RA2013-083: URGENT FIELD SAFETY NOTICE

Description: Triathlon Tibial Alignment Ankle Clamp EM (Instrument)

Catalog #: 6541-2-609

RA2013-08 Product Bulletin Triathlon Tibial Alignment Ankle Clamp

Figure 3

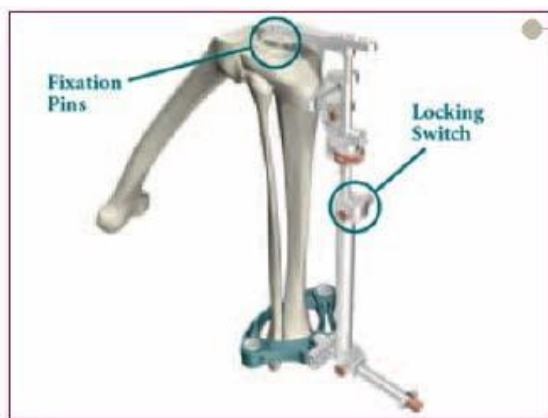
Field Safety Corrective Action Instructions: In the event of a fracture of the ankle clamp portion of the tibial alignment assembly at the flipper (figure 1) or at the yolk (figure 2), the instrument will still function as intended.

The process will remain the same as defined in the surgical protocol (ref. LSPK47 Rev5). Assemble the Tibial Alignment Ankle Clamp to the Tibial Alignment Distal Assembly EM. In case of a compromised Ankle Clamp, firmly hold the Tibial Alignment Distal Assembly EM and press up to/against the Tibia while maintaining alignment. In accordance with the Triathlon Surgical Protocol, flexion / extension alignment is correct when the long axis of the Tibial Resection Assembly parallels the mid-coronal plane of the tibia. Varus / Valgus alignment is similarly assessed per the established methods. (Figure 3)

With a compromised ankle assembly, the surgeon would need to ensure the desired alignment is maintained by holding the assembly in place rather than relying on the stabilization of the ankle assembly. The tibial resection guide would then be pinned in place and the surgeon should proceed with the procedure per the protocol.
